**FEDERAL AVIATION ADMINISTRATION  
AIRWORTHINESS DIRECTIVES**

**BIWEEKLY 2014-07**

*3/24/2014 - 4/6/2014*

**2014-05-10 Airbus Helicopters (Type Certificate Previously Held By Eurocopter France):**  
Amendment 39-17783; Docket No. FAA-2013-0822; Directorate Identifier 2013-SW-004-AD.

### 3.3.3 IN-FLIGHT VIBRATIONS FELT IN THE PEDALS

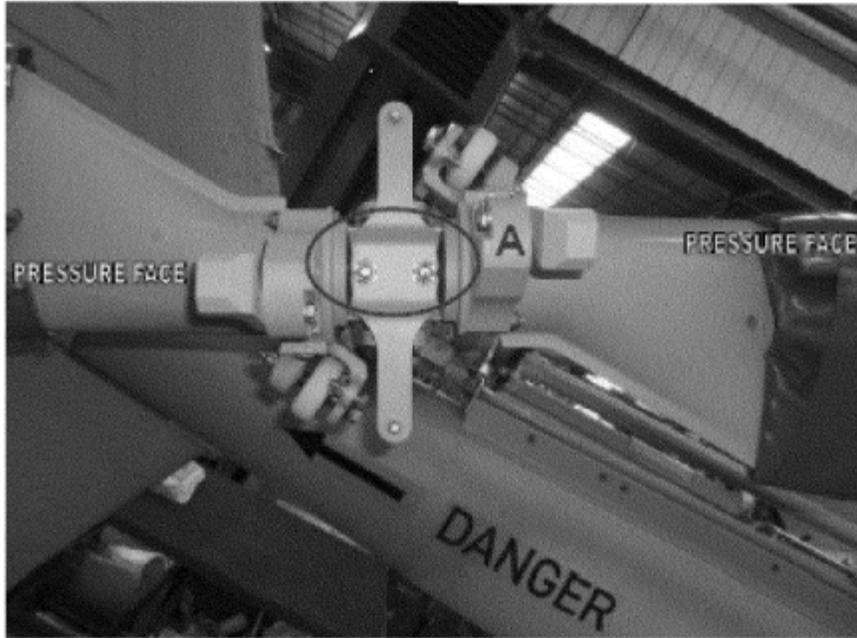
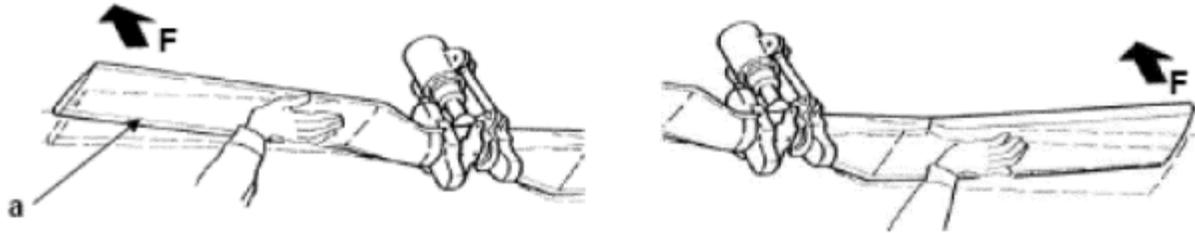
(C) Add the following as paragraph 3.3.3 to the RFM:

1. CHECK PEDAL EFFECTIVENESS
  2. SMOOTHLY REDUCE THE SPEED TO VY
  3. AVOID SIDESLIP AS MUCH AS POSSIBLE
- LAND AS SOON AS POSSIBLE

Figure 3 to paragraph (f)

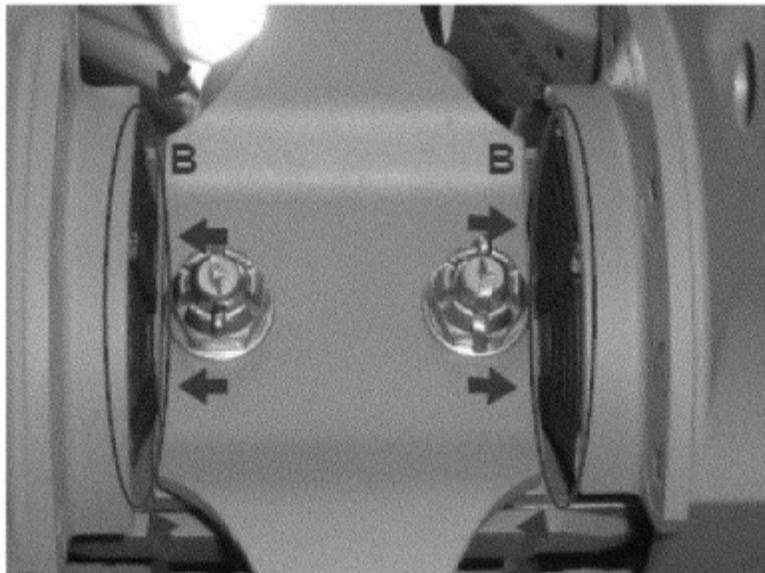
(B) Apply load (F) by hand, perpendicular to the pressure face of one tail rotor blade (a), as shown in Figure 3 to paragraph (f) of this AD, taking care not to reach the extreme position against the tail rotor hub. The load will deflect the tail rotor blade towards the tail boom.

(C) While maintaining the load, check all the visible faces of the bearings (front and side faces) in area B of DETAIL A of Figure 3 to paragraph (f) of this AD for separation between the elastomer and metal parts, a crack in the elastomer, or an extrusion (see example in Figure 4 to paragraph (f) of this AD). A flashlight may be used to enhance the check.

Figure 5 to paragraph (f)

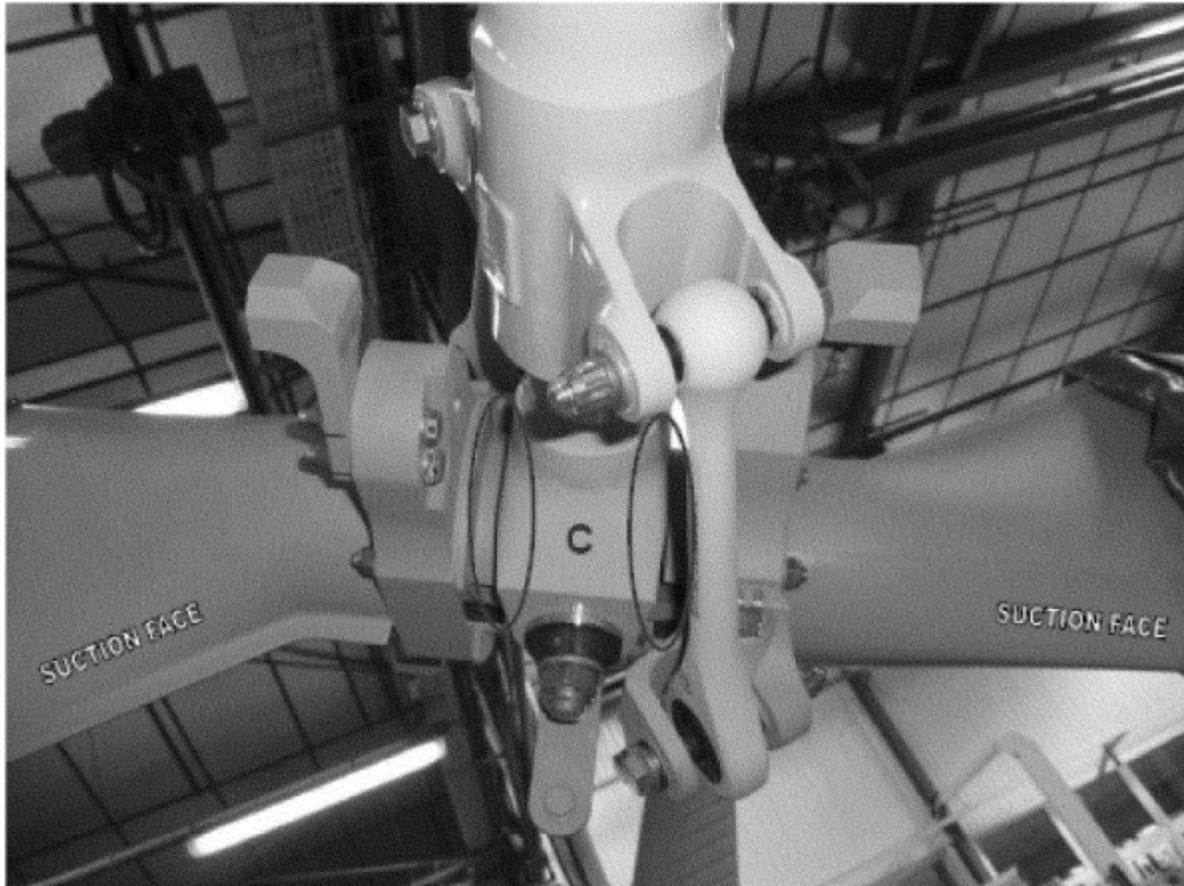
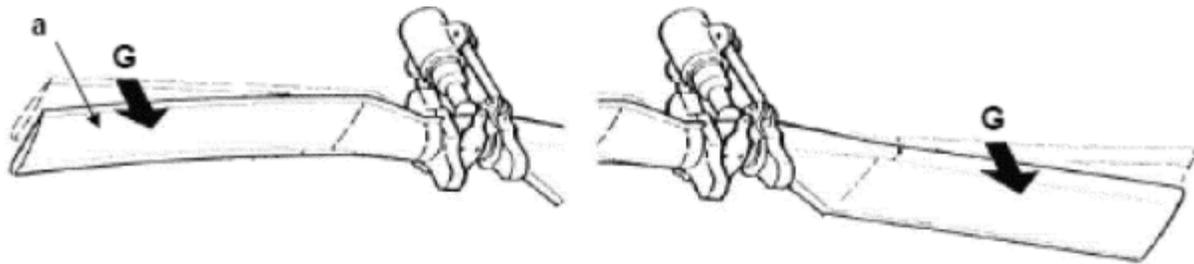
(E) Apply load (G) by hand perpendicular to the suction face of one tail rotor blade as shown in Figure 5 to paragraph (f) of this AD. The load will deflect the tail rotor blade away from the tail boom.

(F) While maintaining the load, check visible faces of Area C as shown in Figure 5 to paragraph (f) of this AD for any extrusion. A flashlight may be used to enhance the check.

Figure 6 to paragraph (f)

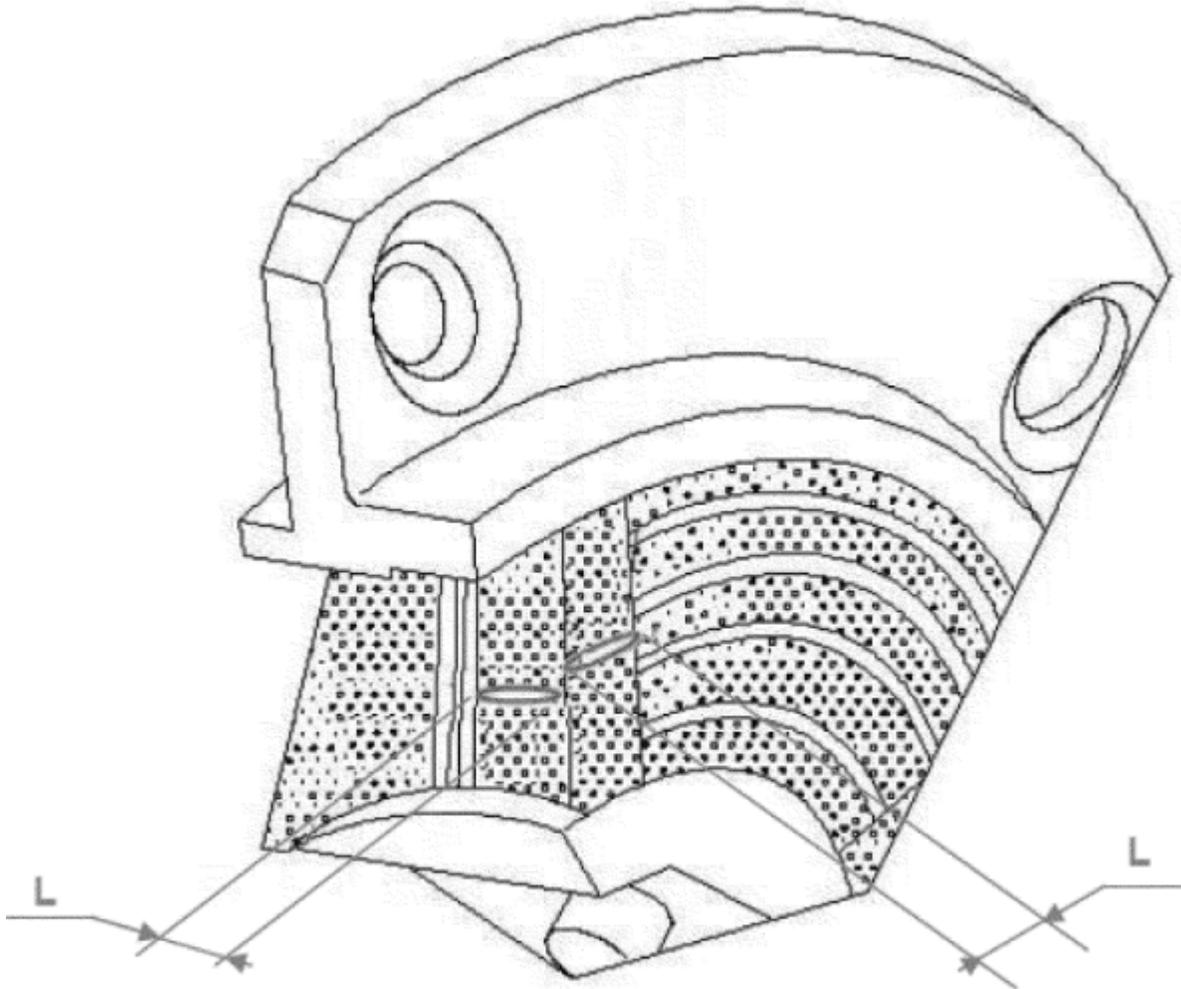
(vi) If there is a separation or a crack on the pressure side bearing, measure the separation or the crack. If the separation or crack is greater than 5 millimeters (.196 inches) as indicated by dimension "L" in Figure 6 to paragraph (f) of this AD, before further flight, replace the four bearings with airworthy bearings.

(iii) If there is a separation or a crack on the bearing, measure the separation or the crack. If the separation or crack is greater than 5 mm (.196 inches) as indicated by dimension "L" and greater than 2 mm (.078 inches) as indicated by dimension "P" in Figure 3 of Eurocopter Emergency Alert Service Bulletin (EASB) No. 05.00.71 or No. 05.00.63, both Revision 2 and both dated December 19, 2012, as applicable to your model helicopter, before further flight, replace the bearing.
